# UNITED STATES PATENT AND TRADEMARK OFFICE

APPLICATION NO.	FILING DATE	FIRST NAMED INVENTOR	ATTORNEY DOCKET NO.	CONFIRMATION NO.
10/627,181	07/25/2003	George N. Kringel	03946-P0001A	3863

This is the second non-final office action for the serial number 10/627,181, PRODUCT DISPLAY DEVICE, filed on 7/25/03.

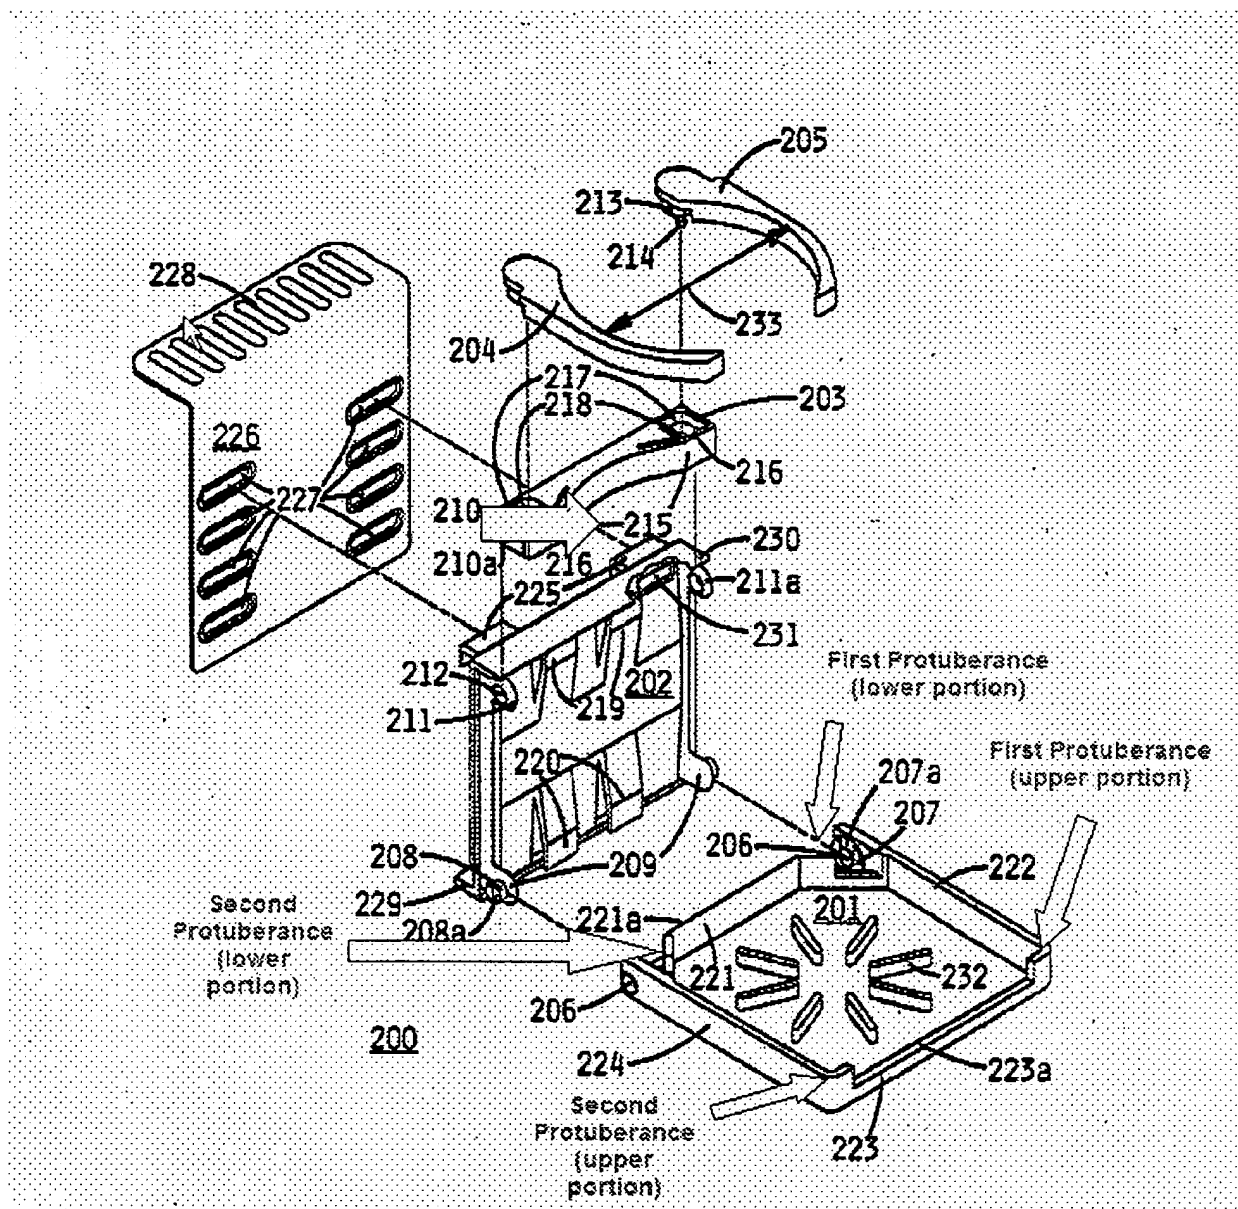
Claims 1-3, 6-11, 13-14, 16-17, 19, 21-25, 32-36 and 38-39 are rejected under 35 U.S.C. 103(a) as being unpatentable over US Patent # 5,167,392 to Henricksen.

Henricksen teaches a device (figure 2) comprising a base (201) defining a receiving area and having a bottom wall with a protuberance (221-224). The device includes a back member (202) extending upwardly from the base and a generally flexible retaining member (204,205 and 215). The back member further comprises a slider (226) and a back bracket (225). The device comprises a tensioner (219) to maintain the retaining member in tension. The base is removable from the back member. The device includes a connector (225-226) engaged with the back member. The base has a protuberance at least partially defining a receiving area. The protuberance has a lower portion (221) and upper portion (223). The first and second protuberances each have a lower portion and an upper portion with the lower portions being closer to the back wall than the upper portions. See drawing of figure 2 shown below for clarification.

Henricksen teaches the flexible retaining member being wrapped around a container but fails to teach the flexible retaining member is adapted to be looped around the container. However, the specification (col. 10, lines 58-68) explains that the retaining member can be adjusted in size to accomadate the size of container, it would have been obvious for one of ordinary skill in the art at the time the invention was made to have made the retaining member to be adapted to loop around the container to secure a smaller size of container within the device.
